# UNITED STATES PATENT AND TRADEMARK OFFICE

APPLICATION NO.	FILING DATE	FIRST NAMED INVENTOR	ATTORNEY DOCKET NO.	CONFIRMATION NO.
10/662,570	09/15/2003	Jonathan S. Stinson	81636D	9734
23685 7590 09/12/2007 KRIEGSMAN & KRIEGSMAN 30 TURNPIKE ROAD, SUITE 9 SOUTHBOROUGH, MA 01772			EXAMINER HOUSTON, ELIZABETH	
			ART UNIT	PAPER NUMBER
			3731	
			MAIL DATE	DELIVERY MODE
			09/12/2007	PAPER

## Office Action Summary

## **DETAILED ACTION**

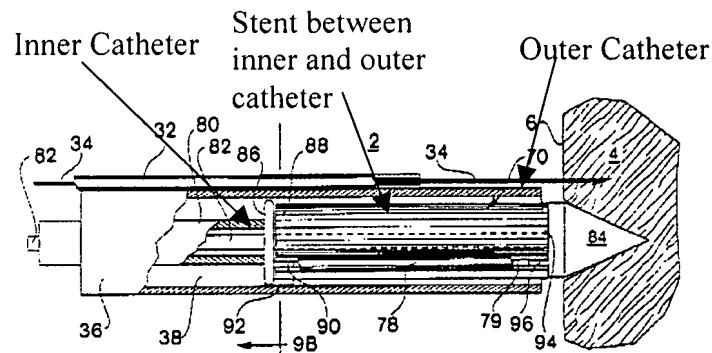
5. Gambale discloses a stent delivery system comprising: an inner catheter (80) with a first lumen; perforating means (82,84) slidably disposed in the first lumen; an outer catheter (36) adapted for axial movement relative to the inner catheter; a self expandable stent (70) disposed between the inner and outer catheter (see below). The stent can be a braided filament (Fig. 5a, b) or non-absorbable plastic (Col 12, line 64). The stent has uniform diameter (Fig. 1B) and is shaped to include a waist of lesser-expanded diameter and a pair of cuffs on opposite ends (Fig. 1D). The perforating means is a retractable needle.

25. Regarding the Gambale reference, applicant states that the prior art does not disclose a stent positioned between the inner and outer catheter. As shown in the figure above, Gambale does disclose a stent that is between the two catheters along the longitudinal axis.
